**To:** Kathryn Espinoza, McKim & Creed  
**From:** Brian Chambers, Senior Planner; 910.342.2782  
**CC:** File;  
**Date:** 2/1/2023  
**Re:** Riverlights SF 7 & 8 TRC Rev 3

Project Name: Riverlights Conventional Phases 7 & 8  
Formal TRC Date: 1/30/2023  
Reviewer: Eric Seidel, PE  
Department: Engineering – Plan Review Section

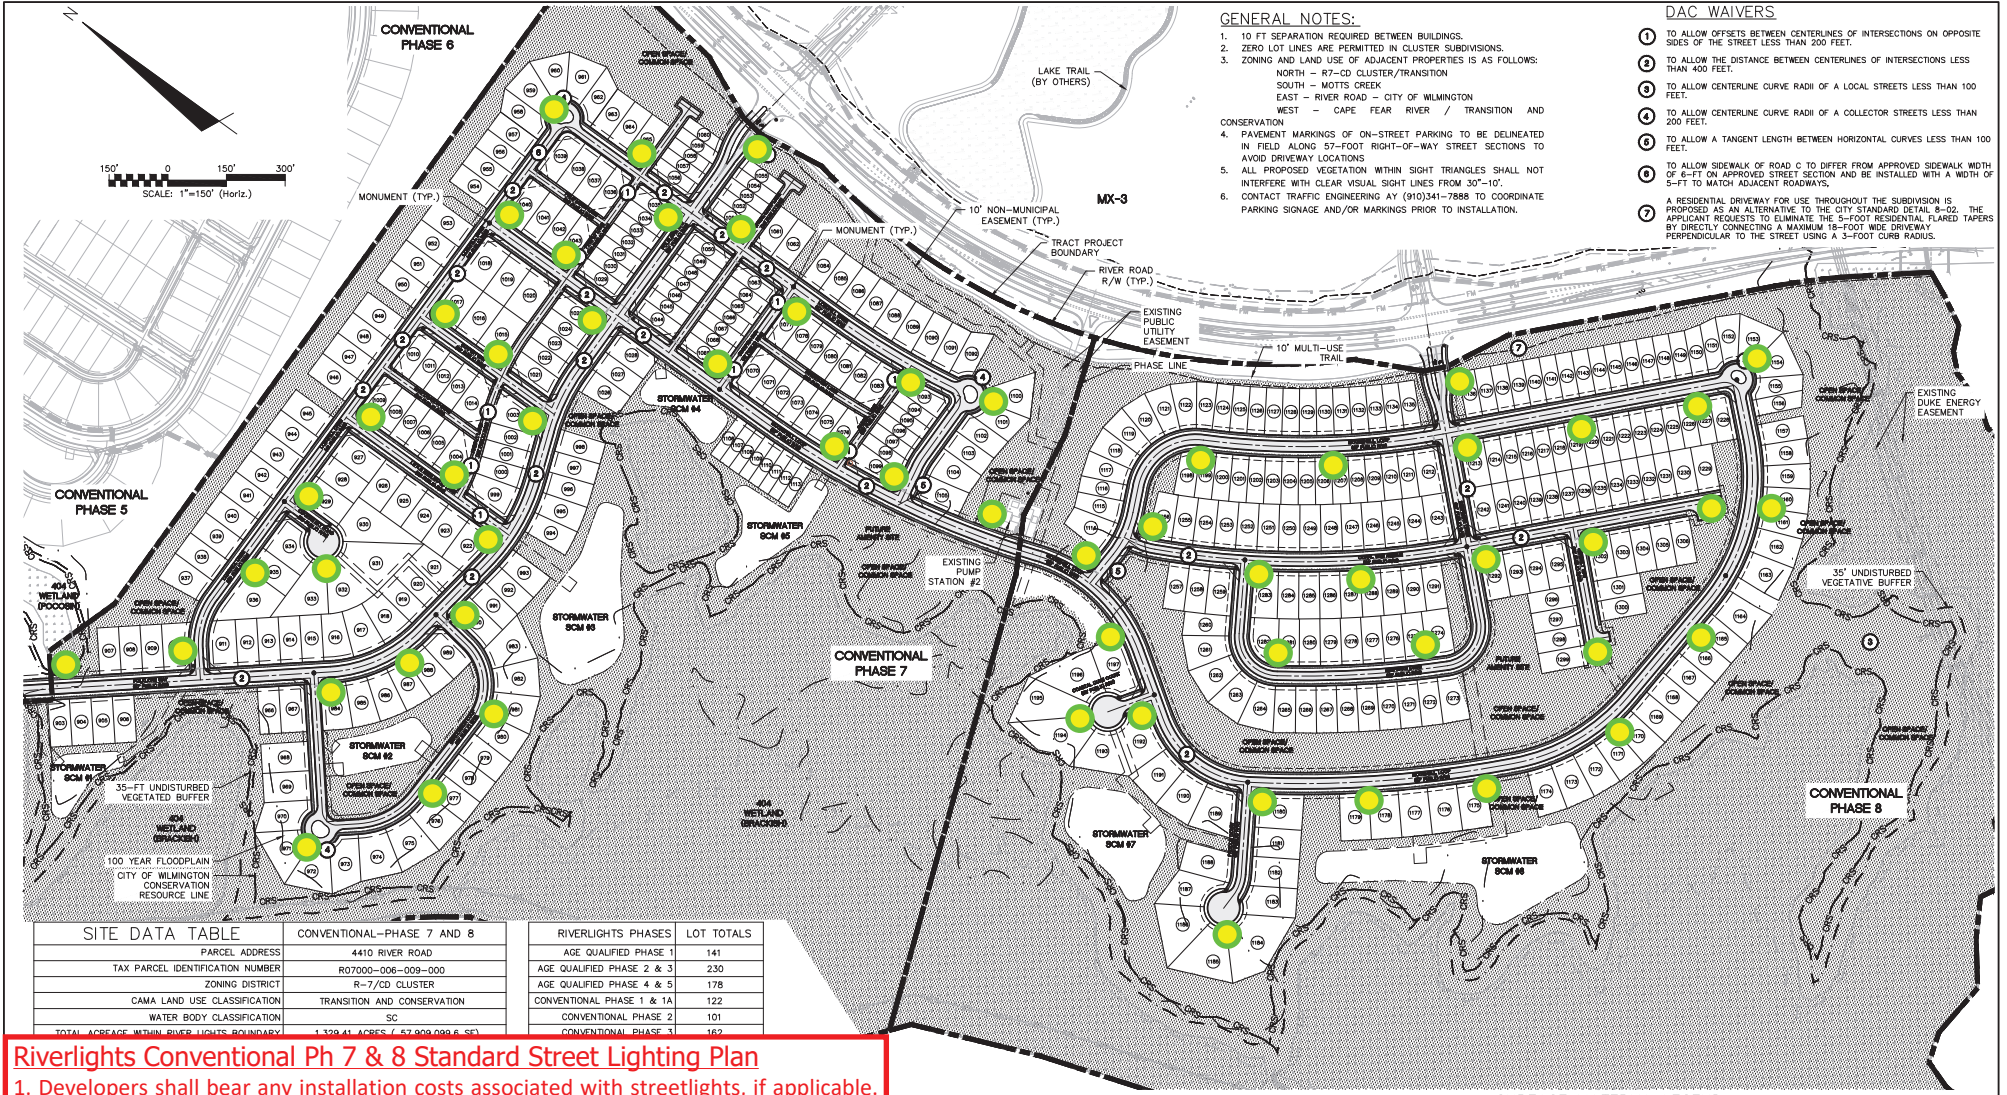
4. If central islands are preferred, please provide all possible turning movements of vehicles maneuvering around and backing out from the driveway of those lots into cul-de-sacs lanes. This is to justify that the lane width proposed are sufficient for the traffic maneuvering.

Show all movements one-way, counterclockwise around central island, similar to roundabouts.

*Response: Fire truck and passenger vehicle autoturns are provided with this submittal for all bulbs.*
